Addendum NO. 01

Date 5/20/2025
Project Name UCA Millcreek Head Start Renovation
Project Number 2025009
Project Phase Permit/Bid
Project Location 336 E 3900 S. Salt Lake City, UT 84107

PROJECT: UCA – Mechanical Addendum

LEVEL 1
MECHANICAL HVAC
PLAN

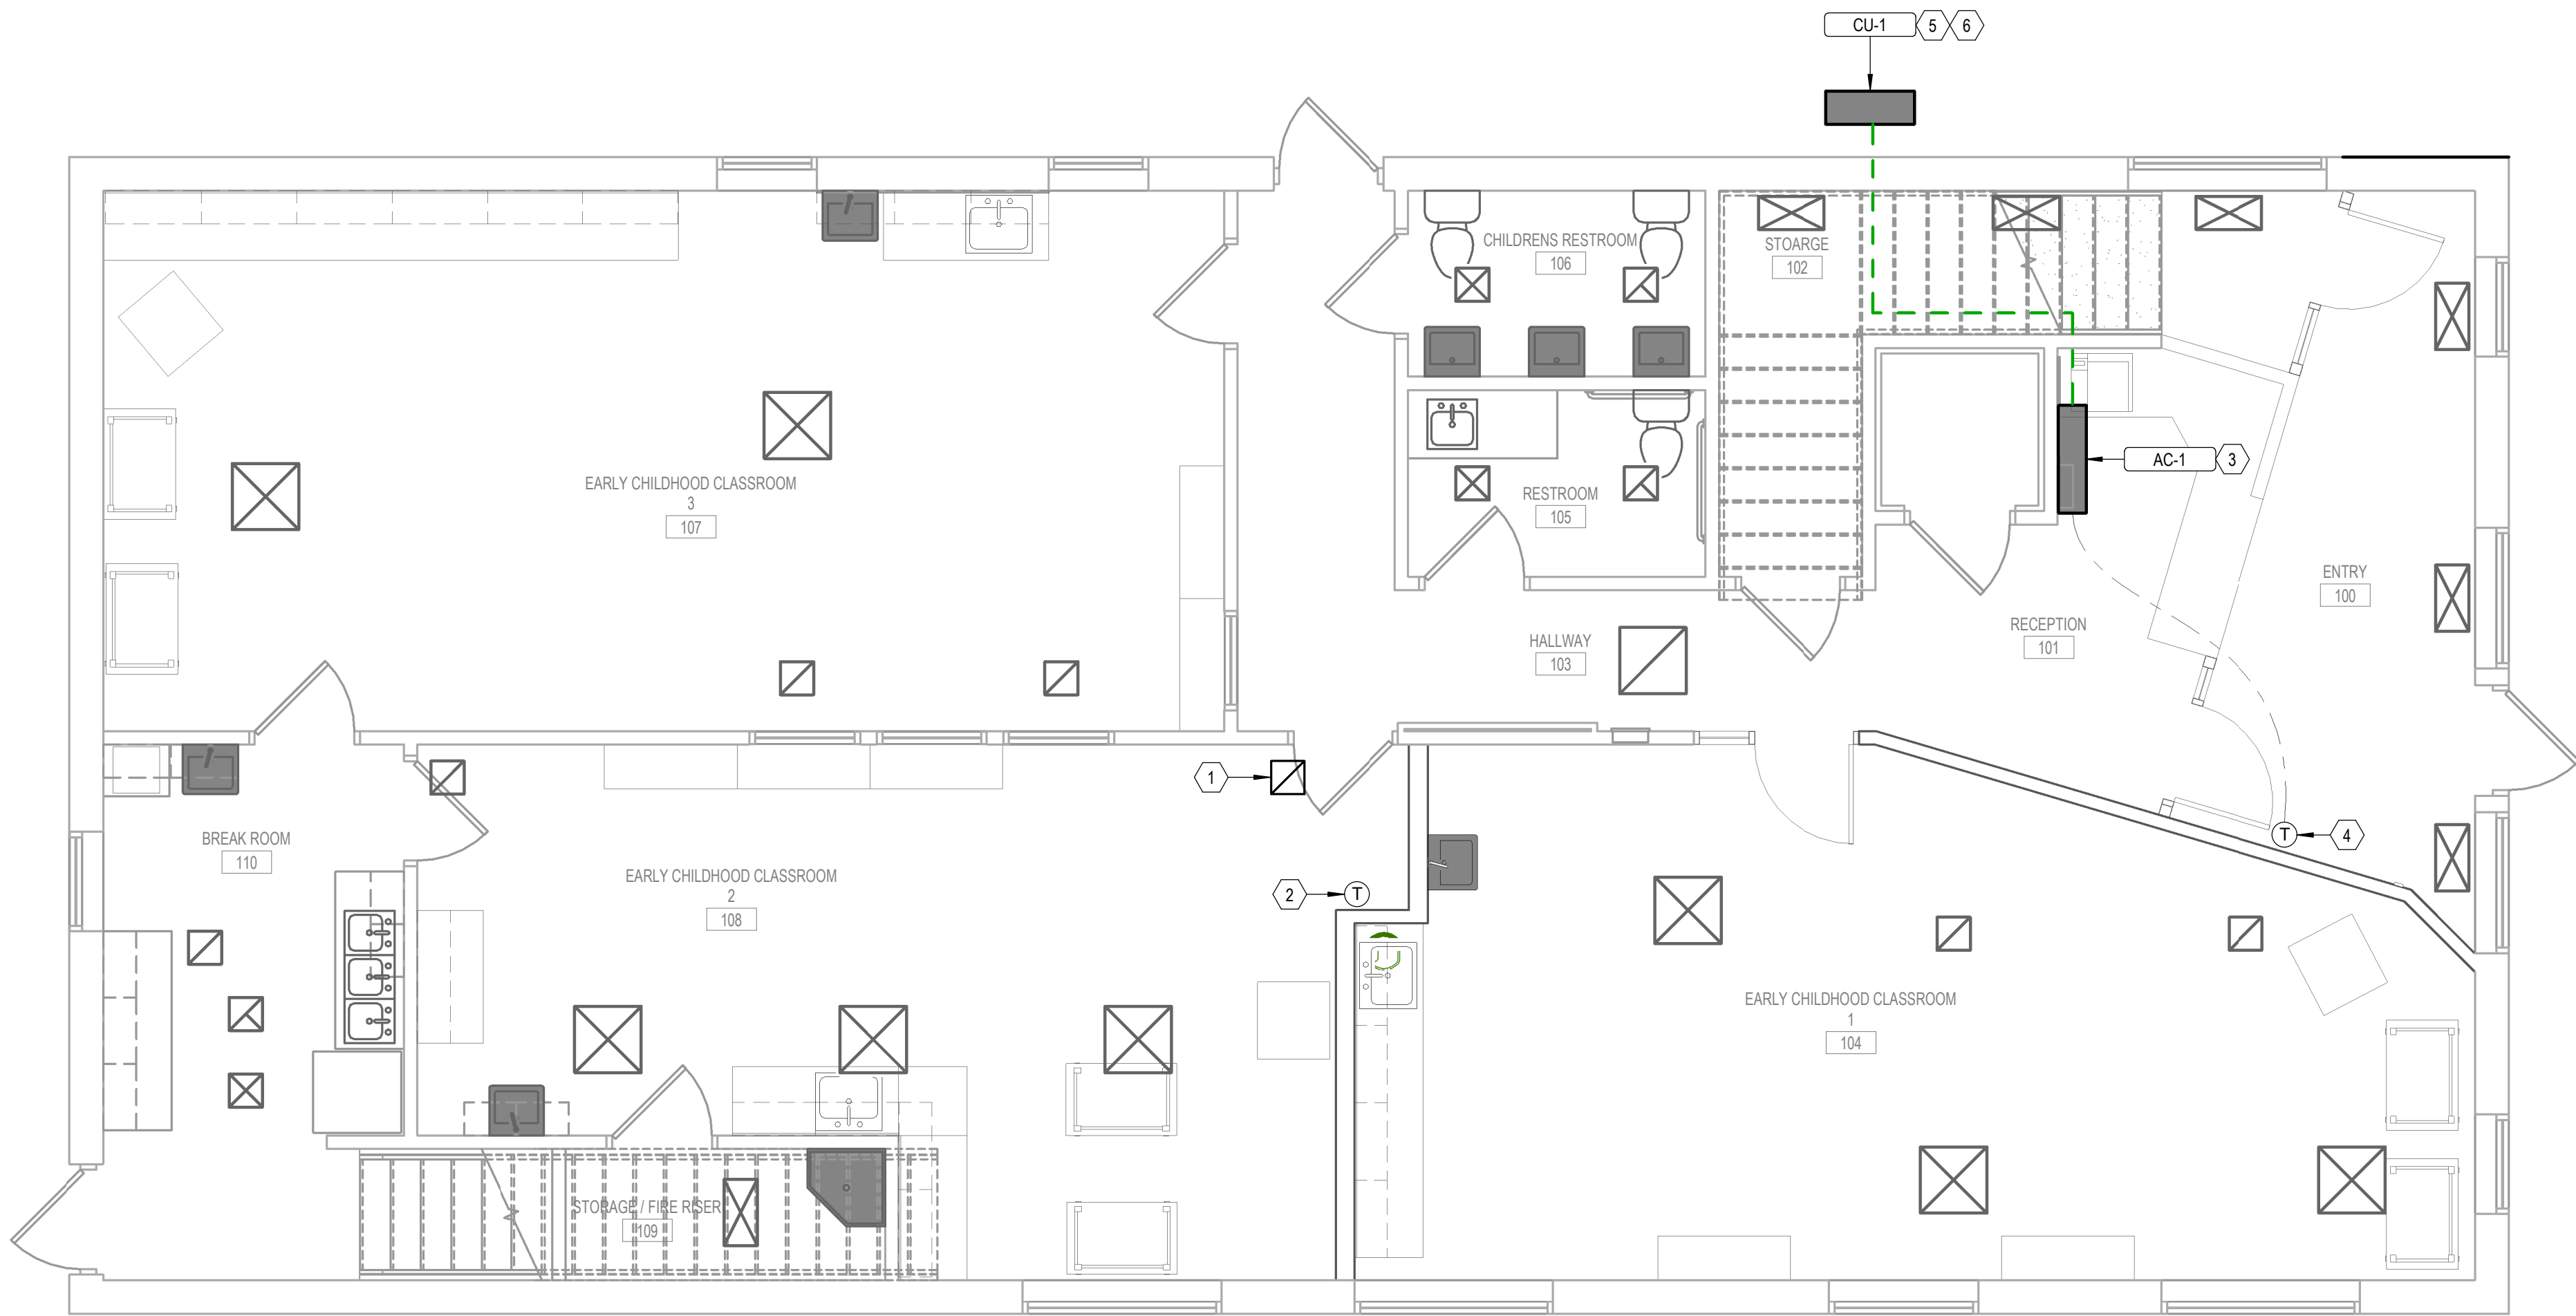
SHEET – M101 LEVEL 1 MECHANICAL HVAC PLAN

1. Changed floor plan to include wall change.
